UCRL-AR-136189

**Explanation of Significant Differences for the
Trailer 5475 Ground Water Remediation,
Lawrence Livermore National Laboratory,
Livermore Site**

February 2000

Figure 3. Proposed treatment method for VOCs in the Trailer 5475 area (shown in conjunction with electro-osmosis).

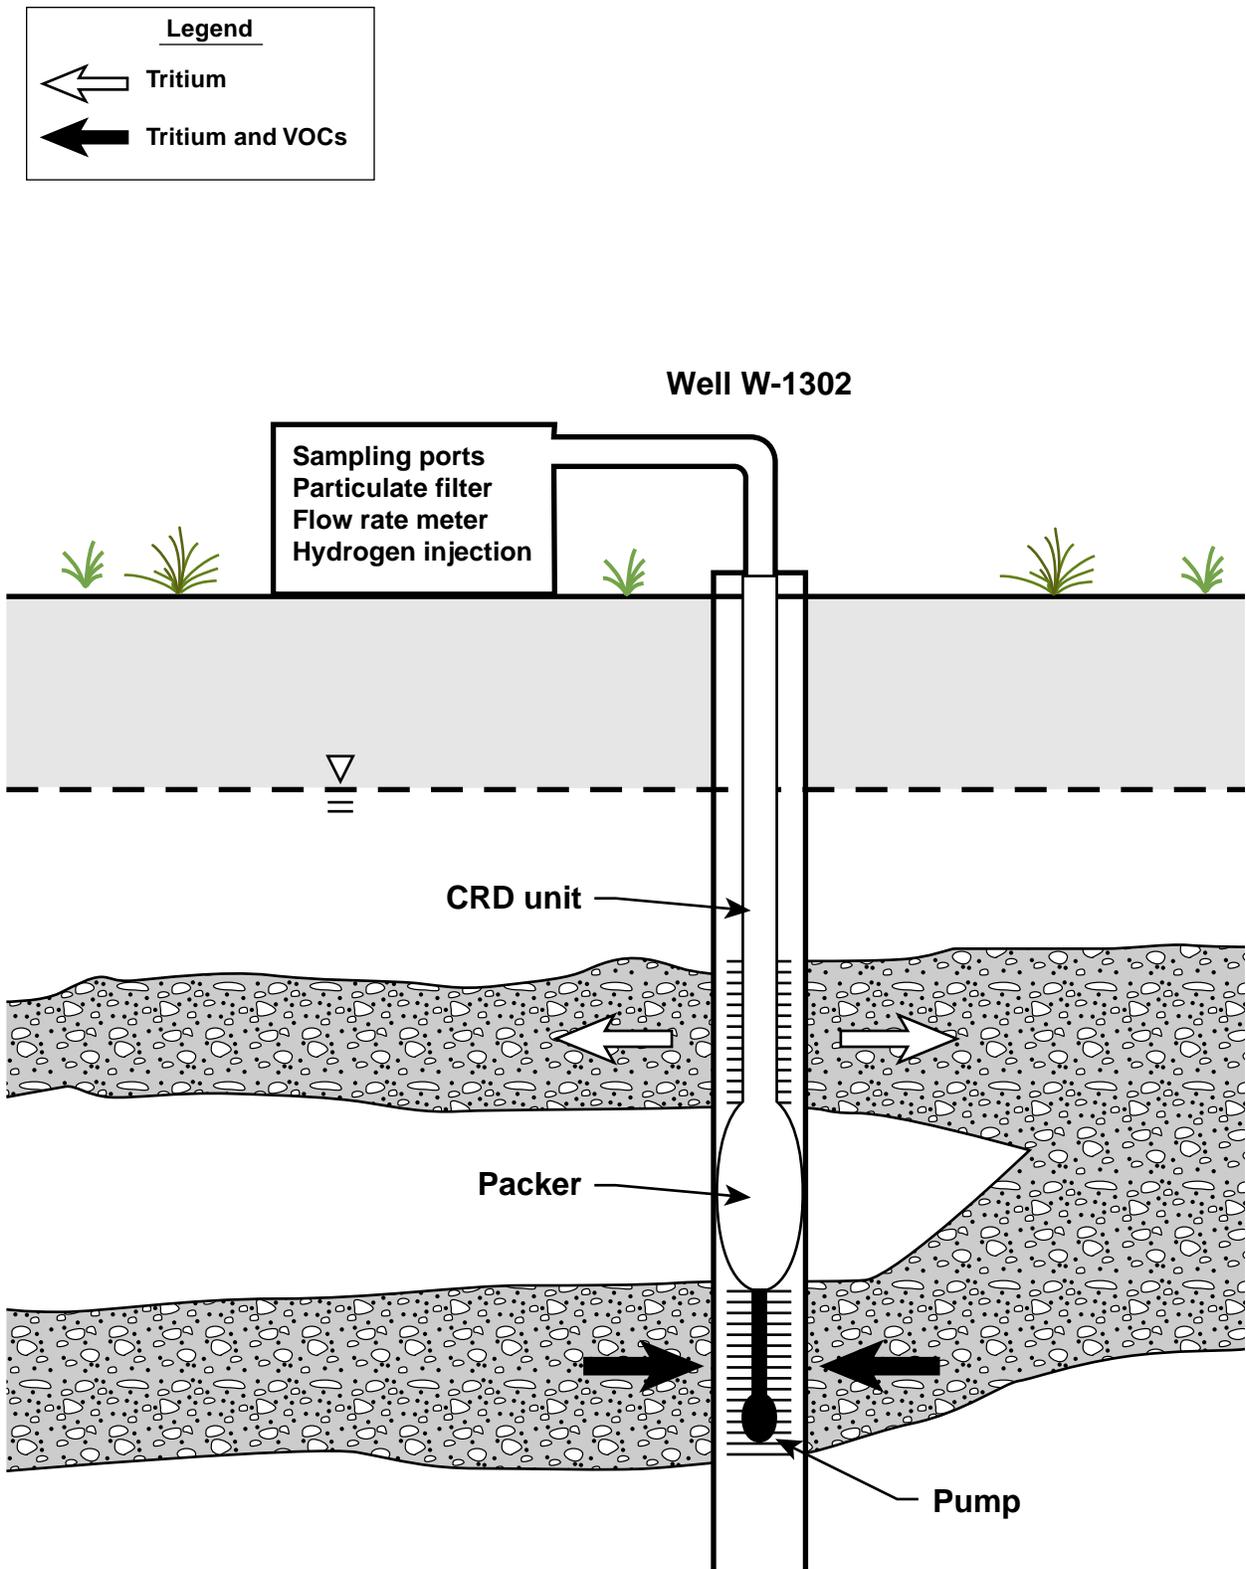
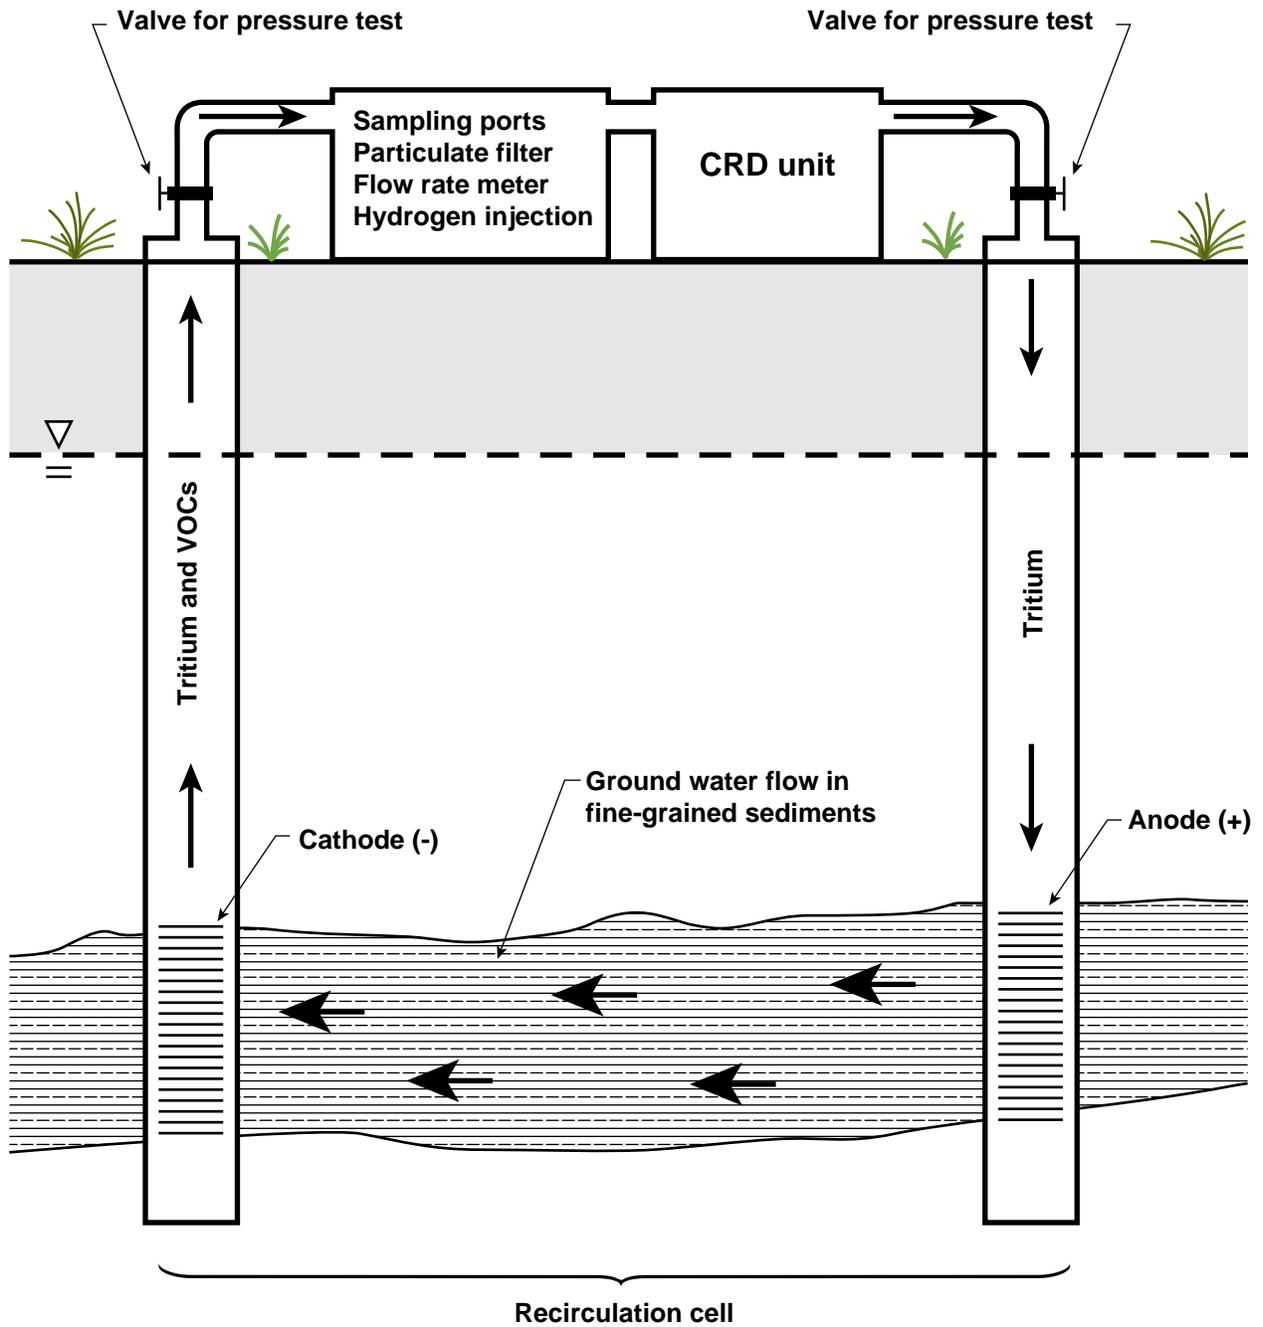
To make this treatment method more effective (e.g., increase flow rates, increase the area of influence, and operate 24 hours per day), DOE/LLNL propose to construct a closed loop system with a CRD treatment unit at the surface. The ground water containing both VOCs and tritium above MCLs will be pumped to the surface where over 90% of the VOCs will be destroyed by CRD, and then the remaining tritiated water will be reinjected back to the subsurface into the same hydrostratigraphic unit from which it was extracted. This change departs from the language in the ROD, yet still follows the primary intent to keep the tritium in the subsurface to decay naturally. The basis for this change is discussed in Section 3.2.

Table 1 describes the significant differences between the current and proposed treatment method (Figs. 2 and 3). Reporting and analysis costs will remain the same from the current remedy to the proposed treatment method. Capital costs will be slightly less than the current treatment method.

- DOE/LLNL plan to use the CRD technology in conjunction with electro-osmosis (EO) (Fig. 3). The EO design will have electrodes in the wells to promote the movement of contaminated pore water in fine-grained sediments under the influence of an electric field. The contaminated pore water will move through the fine-grained sediments to the extraction wells, and will then be treated by CRD to destroy the VOCs. Removing VOCs from the fine-grained sediments is vital to achieving timely cleanup of the Trailer 5475 area. The electrodes in the wells will take up space normally occupied by the CRD unit. An aboveground CRD unit will simplify the design and installation, and can also be sized to simultaneously treat ground water from multiple extraction wells. DOE/LLNL plan to initially operate the system at about 3 gpm, and may eventually operate at about 10 gpm as additional extraction wells are connected.

- There will be a greater area of cleanup in the proposed remedy as the ground water is extracted from one well and injected into another, creating a horizontal recirculation cell (Fig. 3). The recirculation cell created from the current remedy is smaller and more localized because it is only generated between the two screened casing intervals within a single well (Fig. 2).

- Due to deactivation of the CRD catalyst, the current remedy requires the treatment unit to shut down overnight to regenerate the catalyst. The proposed treatment unit at the surface will have at least two CRD units so one can be operating while the other catalyst is regenerating.
